Access Compliance Report

Public Rights-of-Way

(Curb Ramps)

Intersection ID: 23547	Main Street: CASTLEGATE_DR	Cross Street: KNIGHTSWOOD_DR	Location: SE
ADA ID: 8B7F84A7545B	Ramp Type: PerpDiag	Initial Pass/Fail: Fail	Overall Compliance: No
Severity Score: 21.25			
Codes/Mitigation Info/Possible Solution		Field Measurements/Component Compliance

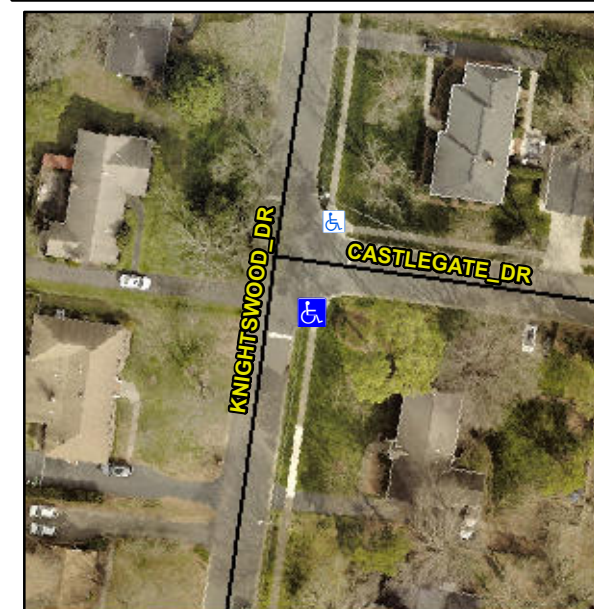
Not Found, R304.5.1, R304.5.3

Compliance	Description	Data	Compliance	Description	Data
N/A	Ramp Length (in)	72.0	Yes	Ramp Slope (%)	7.7
No	Ramp Width (in)	47.0	No	Ramp XSlope (%)	6.4
N/A	Flare Type LT	N/A	N/A	Flare Type RT	N/A
N/A	Flare Slope LT (%)	N/A	N/A	Flare Slope RT (%)	N/A
N/A	Flare Traversable LT?	N/A	N/A	Flare Traversable RT?	N/A
N/A	Landing Length (in)	N/A	N/A	DWS Provided?	N/A
N/A	Landing Width (in)	N/A	N/A	DWS Contrast?	N/A
N/A	Landing Slope (%)	N/A	N/A	DWS Length (in)	N/A
N/A	Landing X Slope (%)	N/A	N/A	DWS Full Width?	N/A
N/A	Landing Curb? (Y/N)	N/A	N/A	DWS Offset (in)	N/A
N/A	Shared Landing?	N/A			
N/A	Gutter Ponding?	N/A	N/A	Gutter Slope (%)	N/A
N/A	Gutter Lip Ht (in)	N/A	N/A	Gutter X Slope (%)	N/A
N/A	Painted X Walk1?	No	N/A	Painted X Walk2?	No
	X Walk 1 Direction	To NE		X Walk 2 Direction	To W
N/A	X Walk 1 Width (in)	N/A	N/A	X Walk 2 Width (in)	N/A
	X Walk 1 Slope (%)	4.4		X Walk 2 Slope (%)	5.0
	X Walk 1 X Slope (%)	5.8		X Walk 2 X Slope (%)	5.4

Remove & Replace Curb Ramp With Two New Directional Ramps or Equivalent.
